DRAWN	DESIGNED	CHECK	APPROVED	DO NOT SCALE	SHEET 1 OF 1
H.S. LEE				DRAWING	
05-30-94				UNIT:	SIZE A2
HUNG CHANG				TITLE	REVISION 0
				HCS9000V RECEIVER	DRAWING NUMBER

DRAWN	DESIGNED	CHECK	APPROVED	SCALE: 1:1	SHEET 1 OF 4
H.S.LEE	H.S.LEE	Samuel		UNIT:	SIZE A3 REVISION D
10-04-94	10-4-94	10-4-94	10-10-94	DRAWING NUMBER S350003-H001D	
				TITLE Thorens TSR 200 HCS9000V MAIN BOARD TOP SILK SCREEN

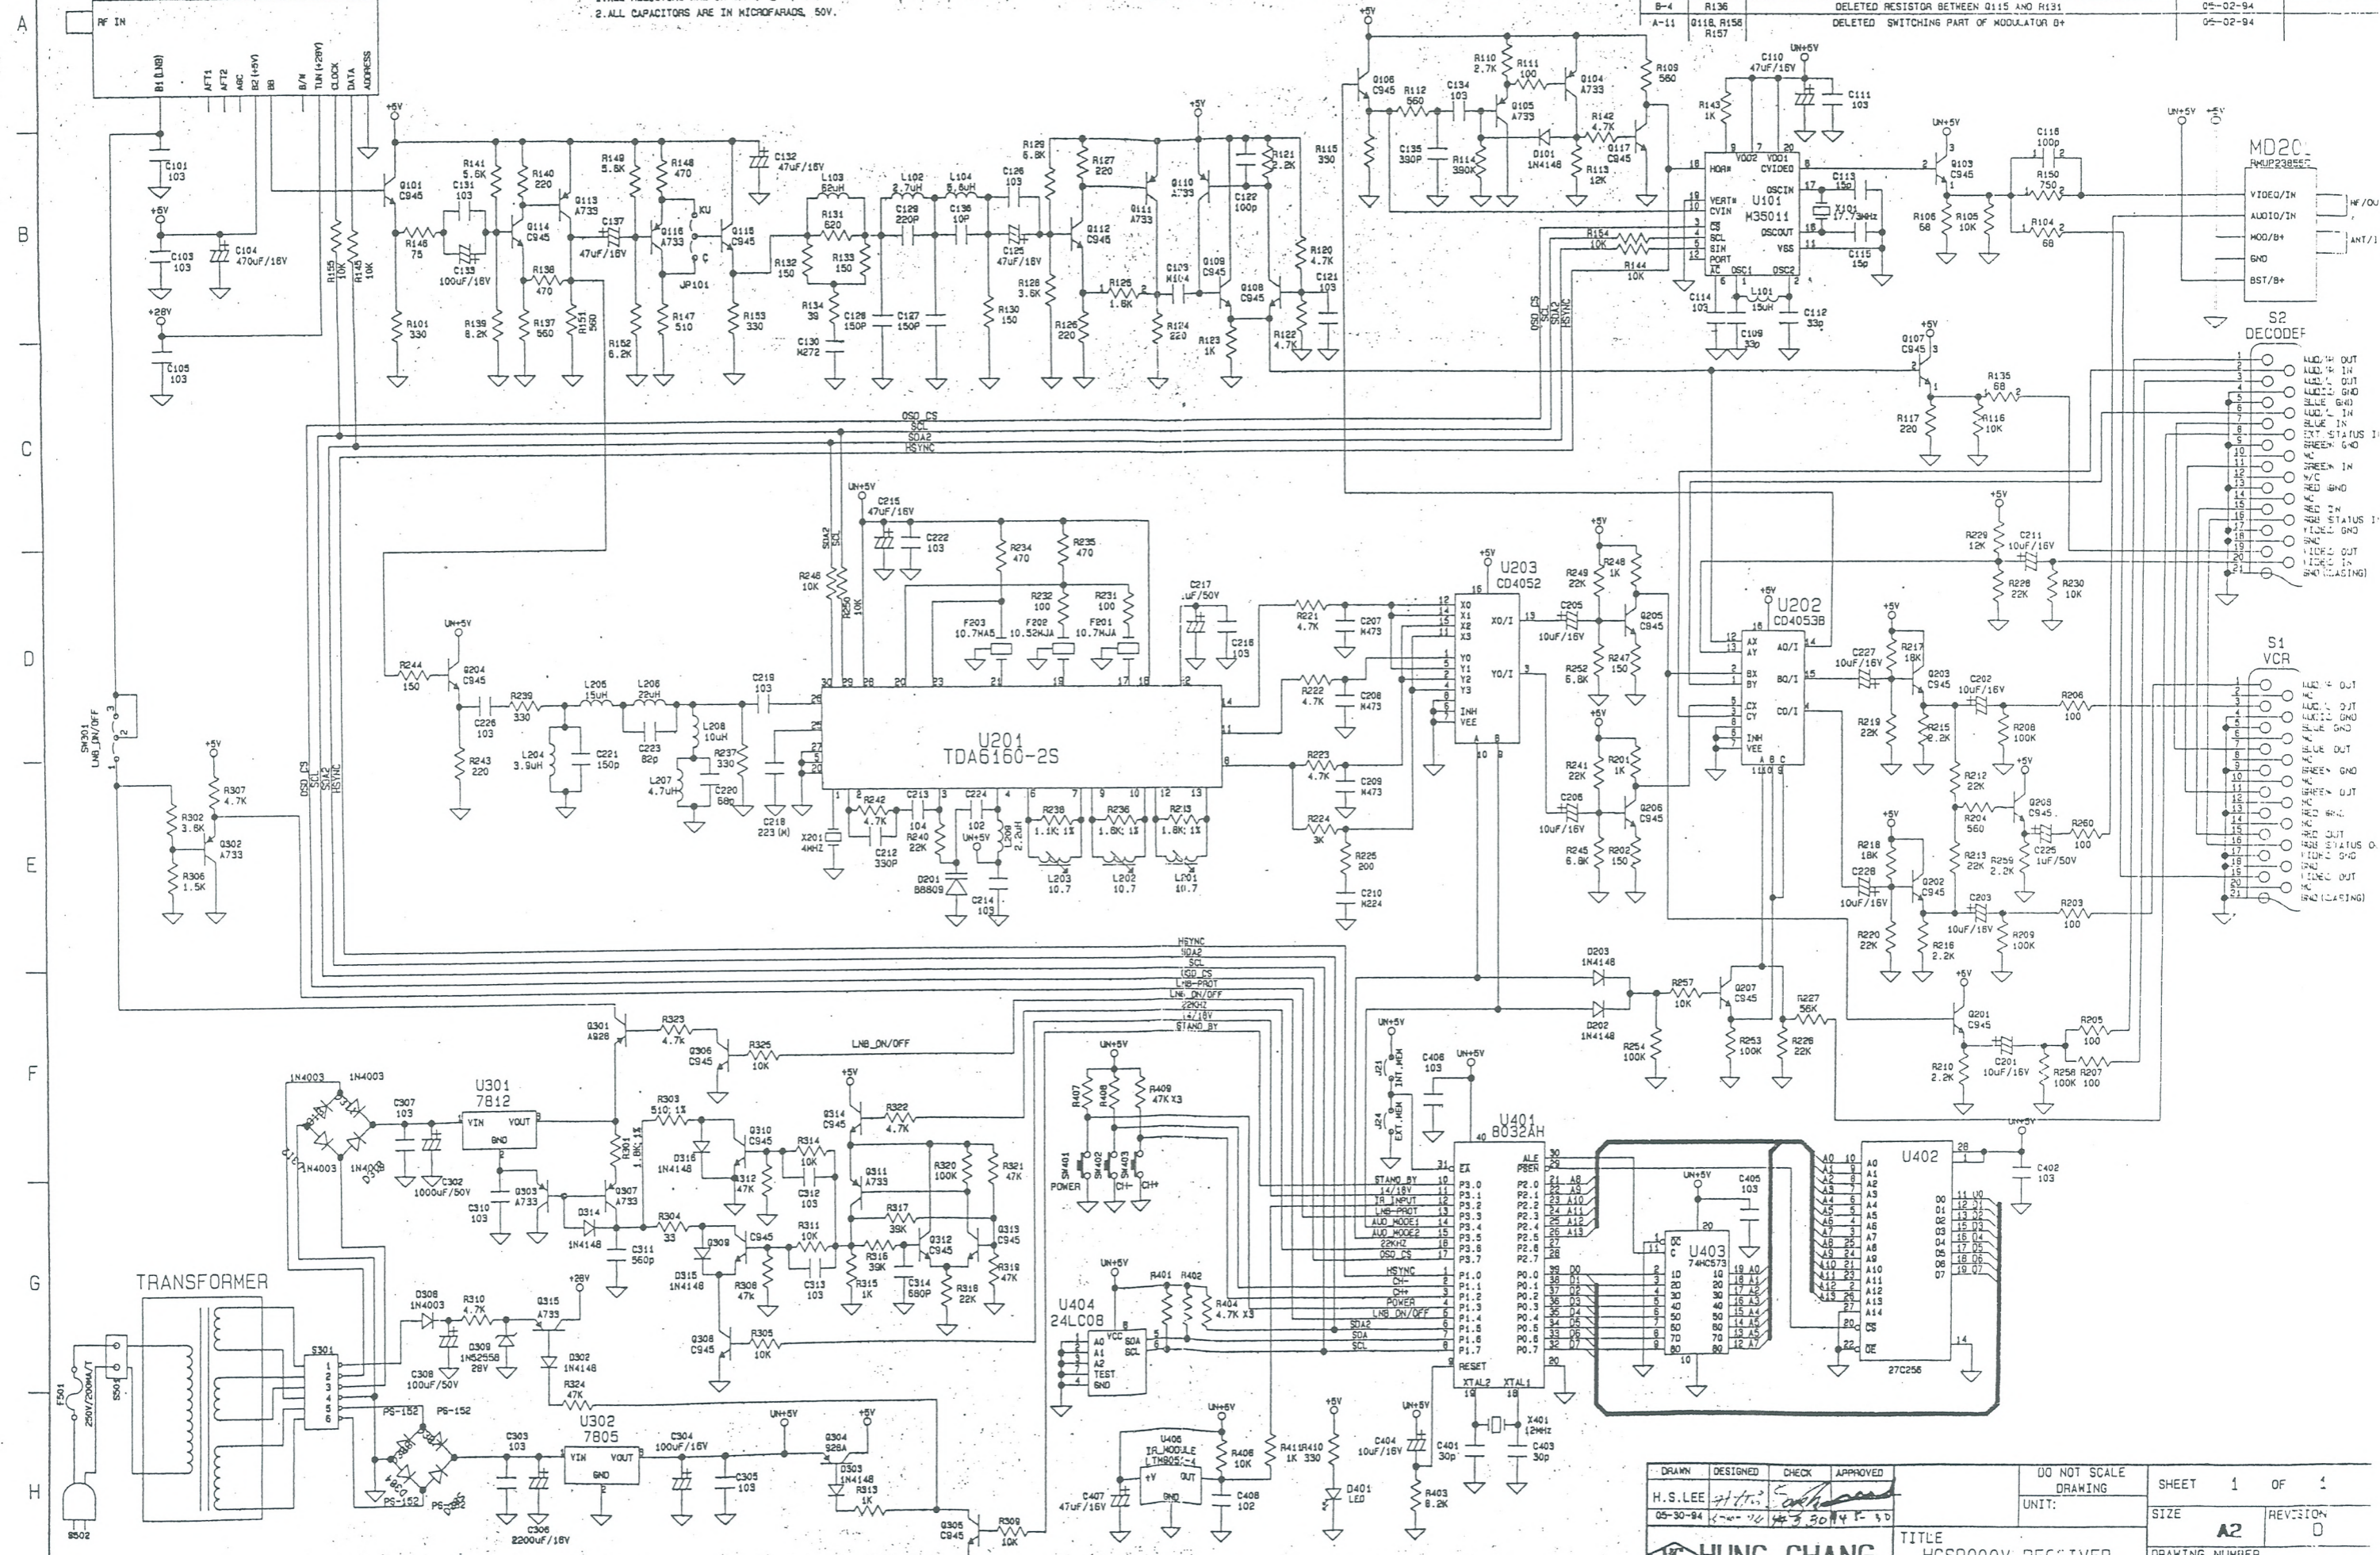
REVISIONS				REVISIONS					
ZONE	REF. DES	DESCRIPTION	DATE	APPROVED	ZONE	REF. DES	DESCRIPTION	DATE	APPROVED
B-10	R150	1k → 750	05-30-94		B-9	R138	4.5K → 470	05-02-94	
F-3	R301	1.8K 1% → 1.8K 1%	05-30-94		B-10	C107, C108	DELETED DC-COUPLING CAPACITOR BETWEEN Q105-1 AND R150-1	05-02-94	
B-8	C124	DELETED CERAMIC CAPACITOR BETWEEN R125-1 AND GND	05-30-94		C-10	C117, C118	DELETED DC-COUPLING CAPACITOR BETWEEN Q107-1 AND R135-1	05-02-94	
					B-4	R136	DELETED RESISTOR BETWEEN Q115 AND R131	05-02-94	
					A-11	Q118, R156, R157	DELETED SWITCHING PART OF MODULATOR B+	05-02-94
